## Relevant Information for Central Sydney Planning Committee

**FILE:** D/2025/184 **DATE:** 18 September 2025

**SUBJECT:** Information Relevant To Item 4 – Development Application: 12-20 Rosebery  
Avenue, Rosebery – D/2025/184

**WMK Response to Recommended  
Condition of Consent**

### I - ADDITIONAL SOLAR SHADING

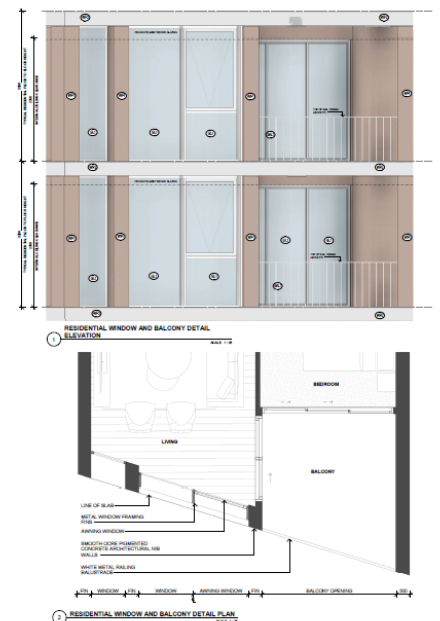
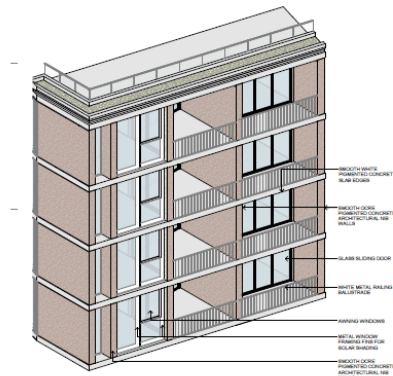
Further solar shading needs to be provided to the western apartments at level 5 and to the northern apartments at lower levels.

The facade treatment has been further developed to address the individual requirements of each cardinal elevation. Depth and setback glazing have been adopted where solar gain is prominent and solar shading is preferable. Northern and western facades have been interglazed and additional shade screens have been applied where applicable.

All apartments comply with BASIX

**CURRENT FAÇADE**

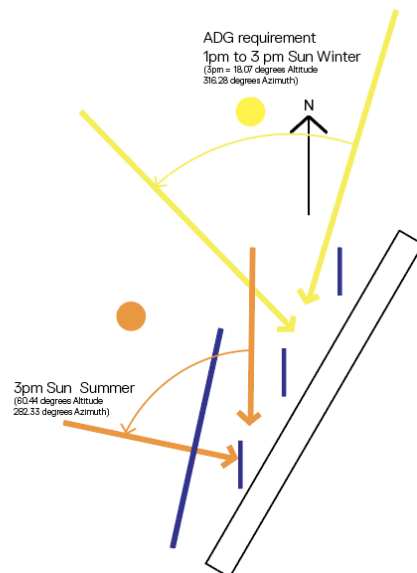
*(c) The plans are to be amended to provide a target of 50% external solar shading (by area) to address summer solar heat gain through:*

*(i) external solar shading to the exposed glazing of the northern elevations of levels 1, 2 & 3 of both the Rosebery and Dalmeny Avenue buildings (50% effective at 12 midday in summer).*

*(ii) external solar shading to the exposed glazing of the western elevation of the Rosebery Avenue and Dalmeny Avenue buildings (50% effective at 3pm in summer). External shading is permitted to intrude in the 3m setback line from Rosebery Avenue for the upper levels. Ground levels to both buildings is excluded from this requirement.*

The proposed development has undergone a rigorous Design Excellence process, including independent review and refinement of facade articulation and materiality. The introduction of additional fixed louvre systems across north and west-facing facades would fundamentally alter the carefully balanced design outcome, obscuring the architectural language that was a cornerstone of the endorsed scheme. These changes are not minor technical adjustments but significant modifications to the built form, facade rhythm, and overall presentation of the project.

#### SOLAR DIAGRAM – CURRENT VS REVISED DESIGN - SUMMER

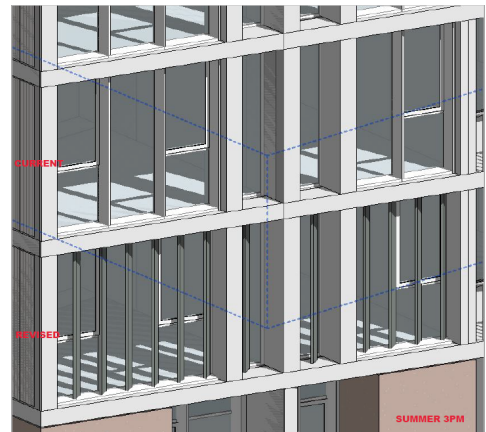
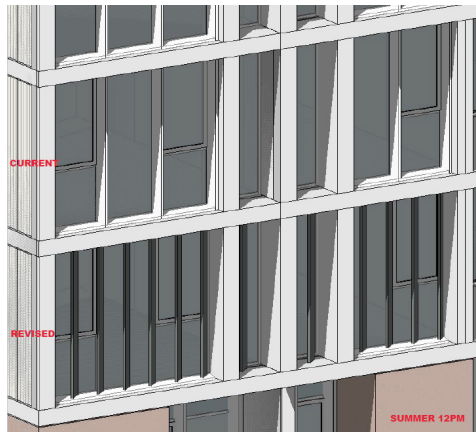
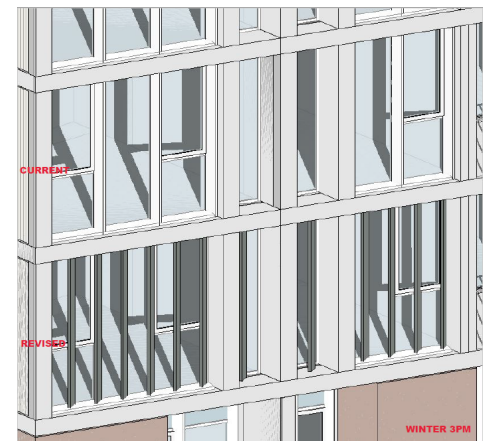
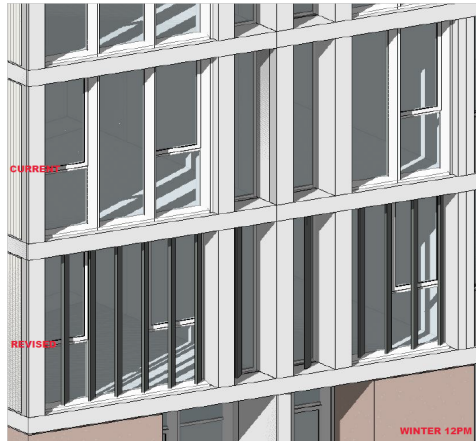
The request for 50% effective shading at 3 pm in summer on western facades directly conflicts with the Apartment Design Guide (ADG) solar access requirements, which require sunlight to penetrate living rooms between 1 pm and 3 pm in winter.

- A fixed external louvre system capable of achieving 50% shading at 3 pm in summer will also block a significant proportion of low-angle winter sun at the same orientation.
- This results in a loss of winter solar amenity, undermining the ADG objective of providing natural light and thermal comfort in the cooler months.

In effect, the two requirements are mutually exclusive — achieving one necessitates failing the other.

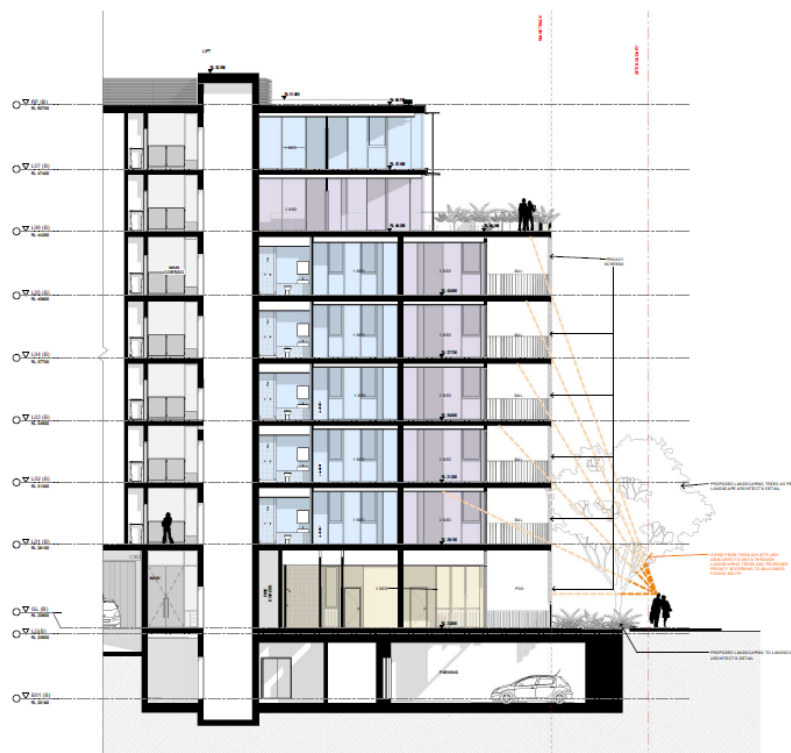
*6 (d) Additional privacy elements are to be incorporated into the private balcony balustrades to provide adequate privacy to private open space from the public domain. This could be addressed via colour matched solid metal upstands being added behind the metal palisade balcony treatments up to a height of 760mm*

Balcony depths to upper-level apartments have been configured to provide privacy when viewed from the street. Landscape fencing, screens and planting have been configured to provide privacy to ground floor apartments.

The below diagram depicts a privacy view from the street showing direct views into the apartments from the public domain does not occur.
